PLANNING APPLICATION

PROJECT / LOCATION		DRAWING	
PLEMONT BAY PLEMONT 28 HOUSES DEVELOPMENT		HOUSE 12 FIRST FLOOR PLAN	
CLIENT	DRAWN	CHECKED	
PLEMONT ESTATES LTD	EN	PH	
DATE	SCALE	DRAWING NUMBER	
JUNE 2010	1:50 @ A0	1871/F/02	C

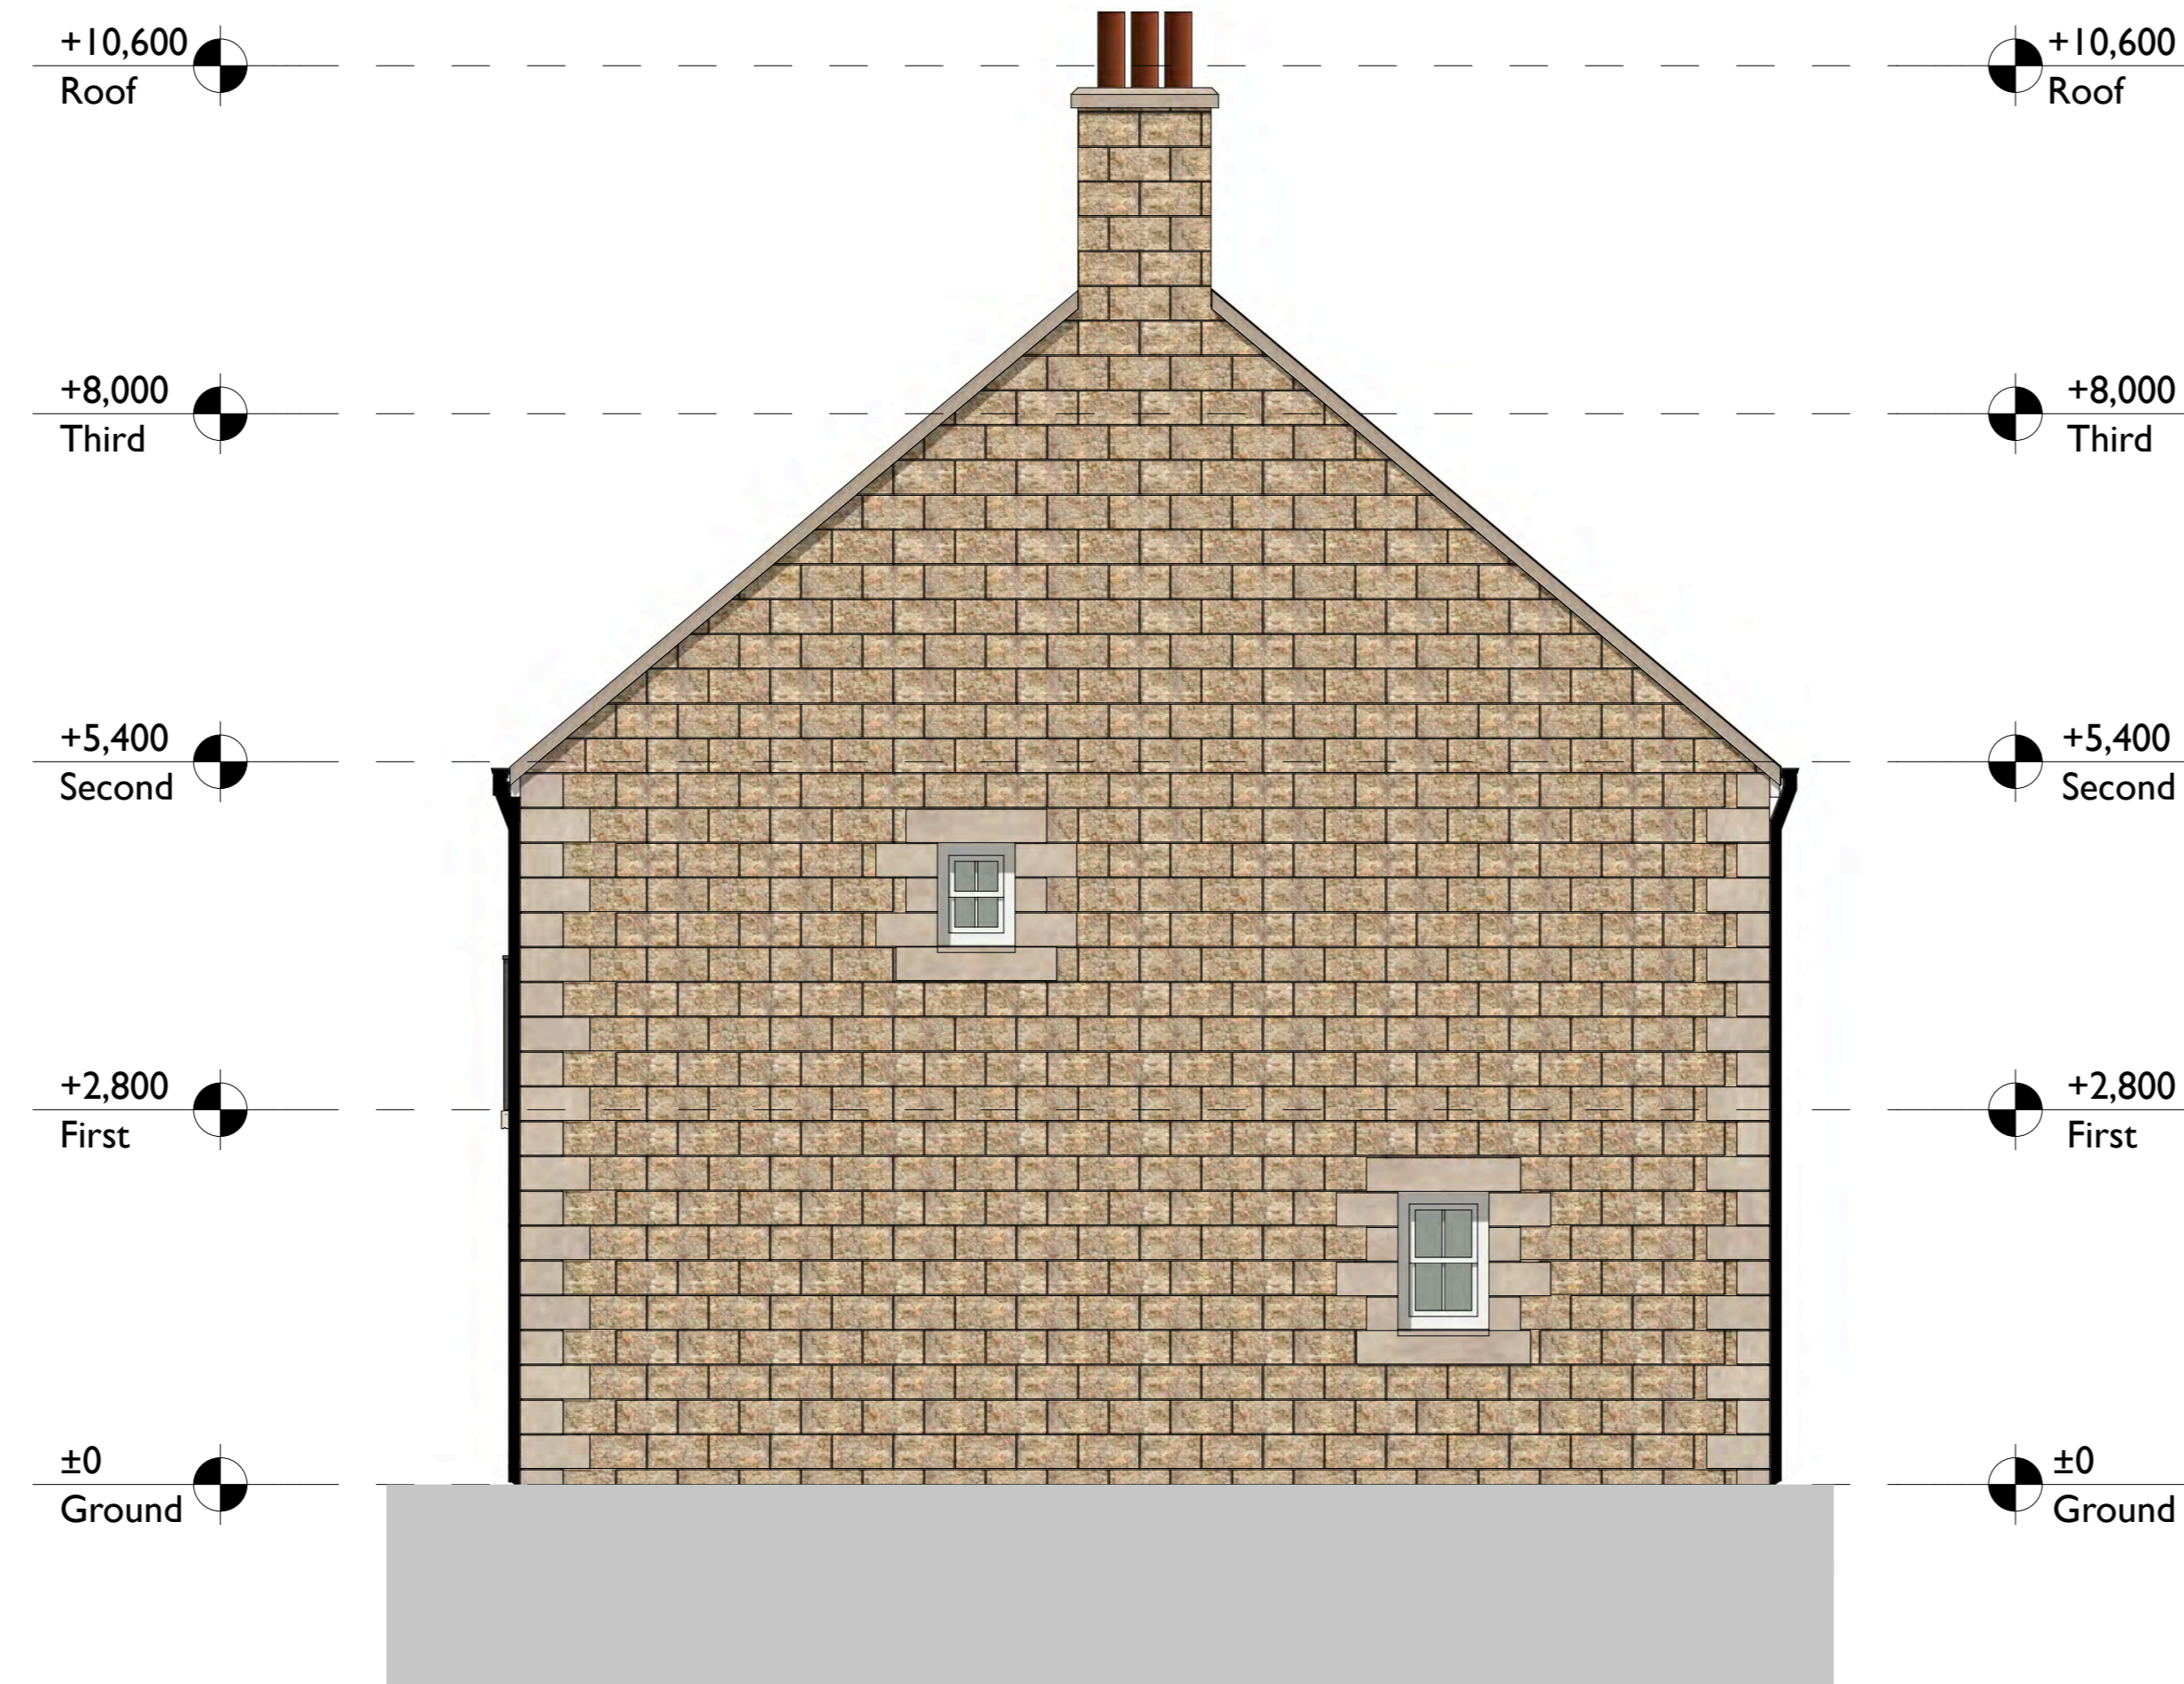
A	June 2010	Scheme revised to 28 houses as directed by Planning & to Planning Department requirements	EN/SB
B	July 2010	Scheme revised as directed by Planning Department	PM
C	Sept 2010	Revisions to further Planning requirements: a) Witches' stoops to chimneys removed b) Garage moved West by 450mm c) Rear (west) window reveal trimming changed to regular quoins as front elevation d) Small window added to garage at ground floor level e) Rear (West) first floor windows regularised to sit central over ground floor patio doors f) Garage pier on East (front) elevation brought round in render g) Garage doors refined with angled beams removed, door pair and hinges showing	PM
